MODELS **37GT25H** (S/N 107****~) **51GT25H** (S/N 107****~)

SYMPTOM Tuning drift

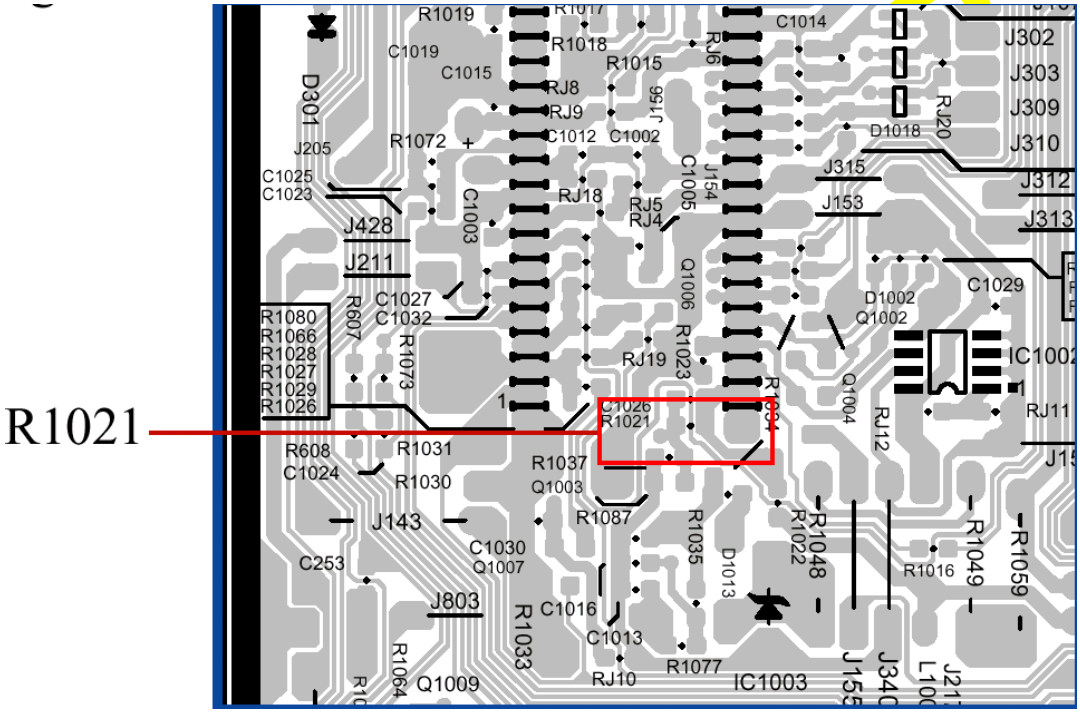
CAUSE R1021

ACTION For units with serial numbers below that shown above, change the value of R1021 from 22k to 12k, using the part number given below.

Note that this resistor has been changed from July 2001 (serial numbers after the one shown above).
